HISTORIC AND DESIGN REVIEW COMMISSION

September 18, 2019

HDRC CASE NO: 2019-117
ADDRESS: 434 SHERMAN ST
LEGAL DESCRIPTION: NCB 514 BLK 18 LOT E 75 FT OF 13
ZONING: R-6, H
CITY COUNCIL DIST.: 2
DISTRICT: Dignowity Hill Historic District
APPLICANT: Alvin Peters
OWNER: Waseem Ali Stephanie Zarriello
TYPE OF WORK: Construction of a 2-story, single-family residential structure
APPLICATION RECEIVED: February 27, 2019
60-DAY REVIEW: April 28, 2019 (Referred to DRC and postponed by applicant)
CASE MANAGER: Edward Hall

The applicant is requesting conceptual approval to construct a two story, single family residential structure on the lot at 434 Sherman Street, located at the corner of Sherman and N Olive, within the Dignowity Hill Historic District.

MEDIAN SETBACK

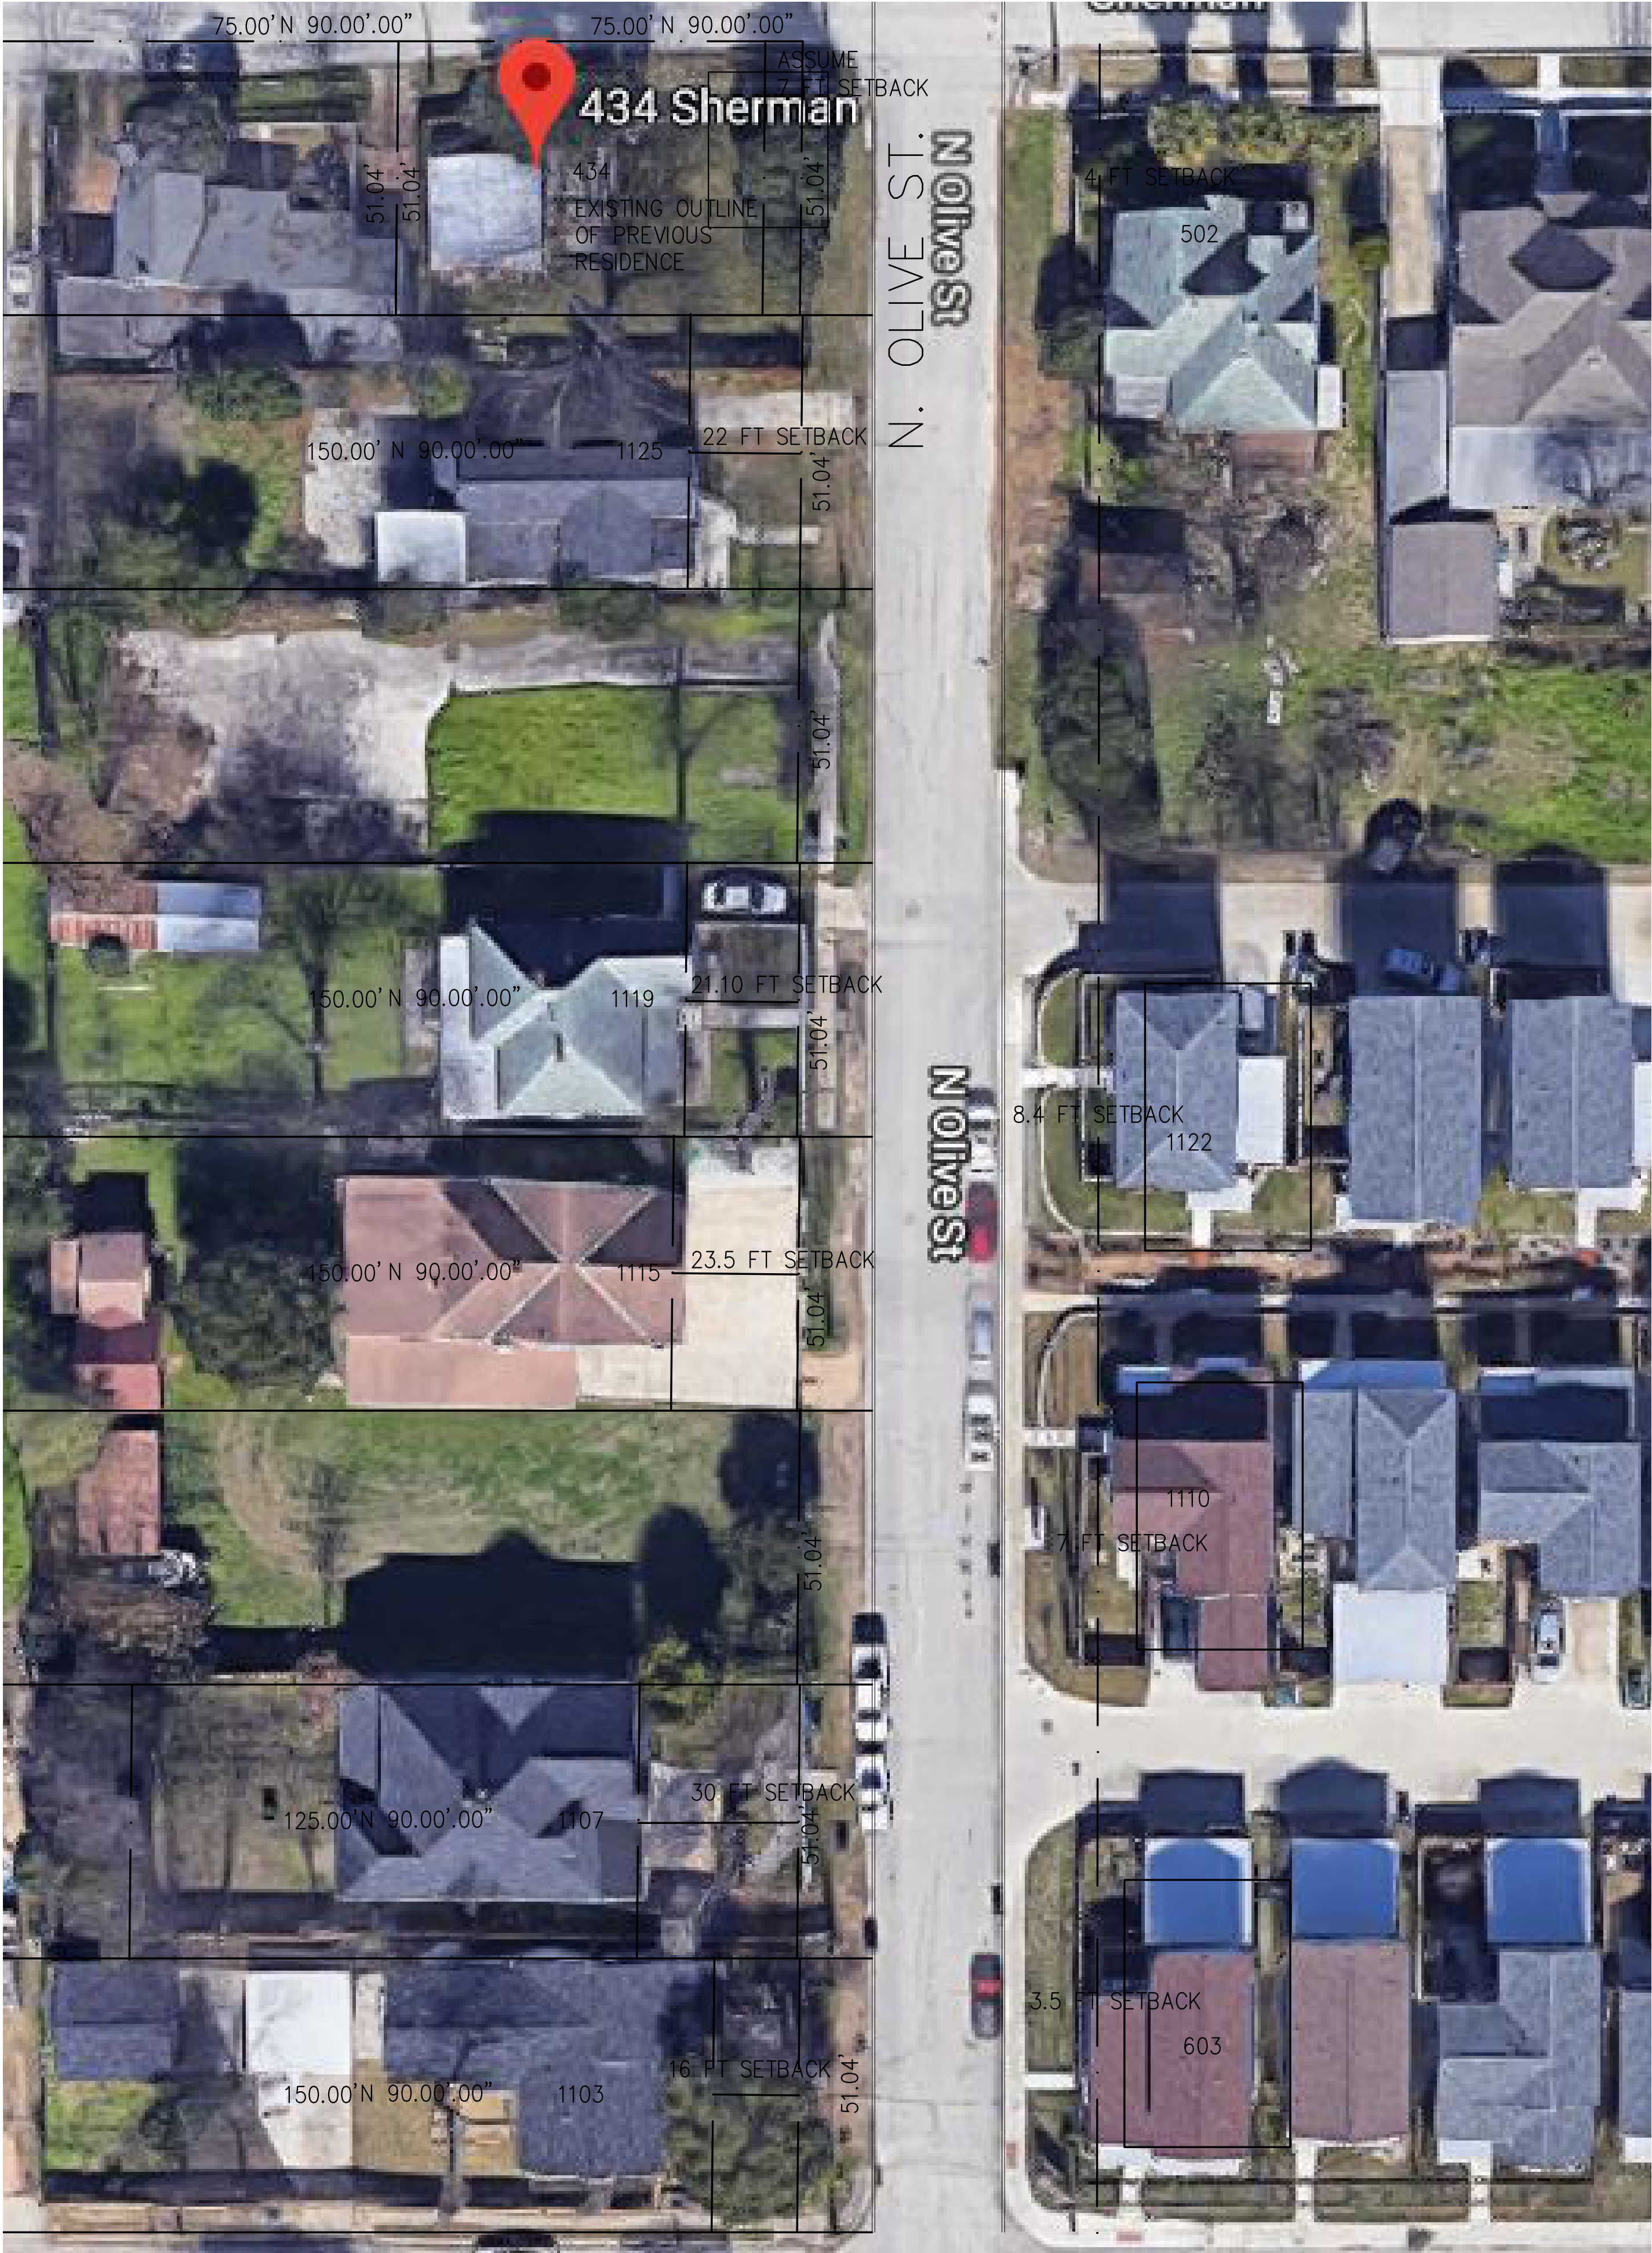
- i. **SETBACKS & ORIENTATION** – According to the Guidelines for New Construction, the front facades of new buildings are to align with front facades of adjacent buildings where a consistent setback has been established along the street frontage. Additionally, the orientation of new construction should be consistent with the historic examples found on the block. The applicant has proposed a front setback that is less than those found historically on the block. While there may have been a historic structure with a shallow setback on this lot, staff finds that new construction should feature a greater setback than the historic structures on the block.

- i. That a setback that is greater than those found historically on the block be used as noted in finding i.
- ii. That a front facing (toward N Olive) door within the front porch be installed to match historic porch profiles be installed as noted in finding k.

PER COSA HISTORIC GUIDELINES
 FOR NEW CONSTRUCTION FOR 4.A.i. SETBACKS;
 ”USE THE MEDIAN SETBACK OF BUILDINGS ALONG THE STREET
 FRONTAGE WHERE A VARIETY OF SETBACKS EXIST”

Olive and Sherman Streets. (Refer to Sanborn Maps and Google Photos on Sheet A1.2) We are Proposing a Front Setback of 13' which complies with the current Zoning Front Setback requirement of 10'.

01 PROPOSED HOUSE ROOF PLAN

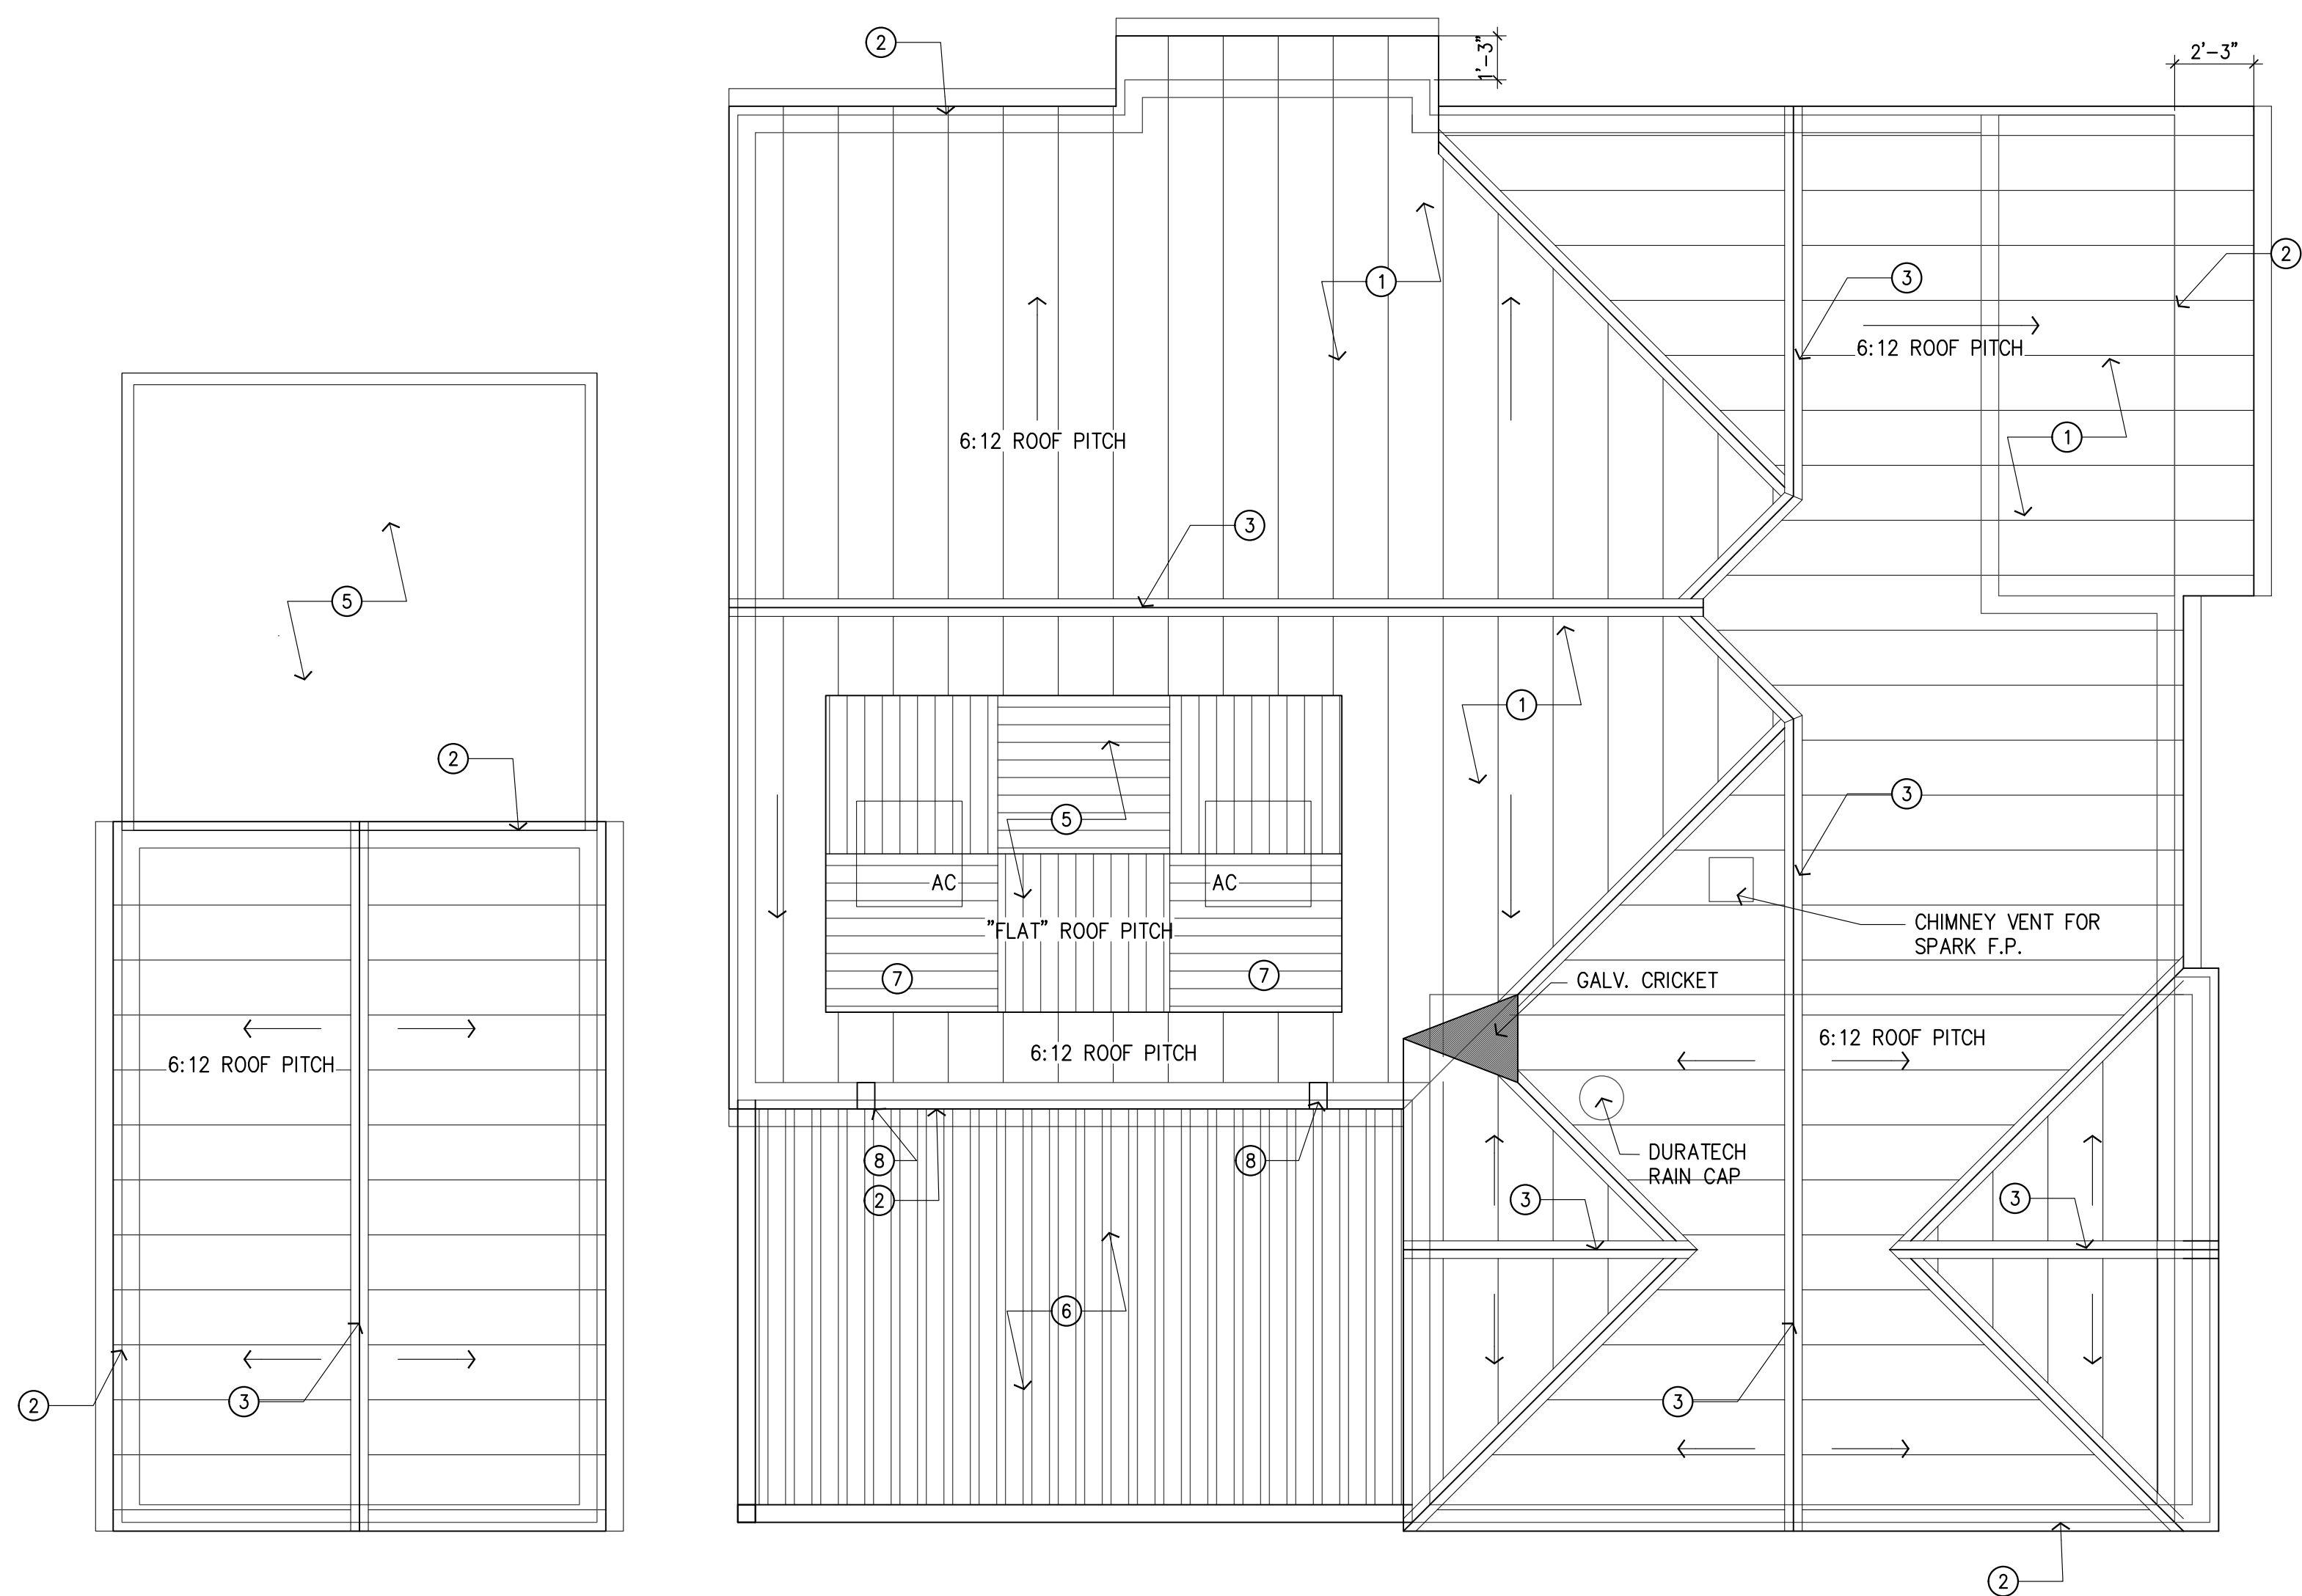
- n. **ROOF FORM** – The applicant has proposed a number of roof forms for the proposed new construction, including hipped and gabled roofs of various proportions and profiles. Historic structures on both Sherman and N Olive feature front facing gabled roofs with other forms including hipped and shed porch roofs. Staff finds that a simplified roof form with consistent ridge heights would be more complementary of those found historically in the district.

- v. That the applicant proposed simplified roof forms that feature consistent ridge lines and do not feature complex valleys that are not found historically within the district, as noted in finding n.

- l. We Concur, See revised sheets A4.1 A5.1 and A5.2.
- m. We Concur, See Wood Window Details A5.1.
- n. We Concur and have redesigned the roof form to a more traditional Gable and Hip design as suggested by Jeff Fetzer FAIA.
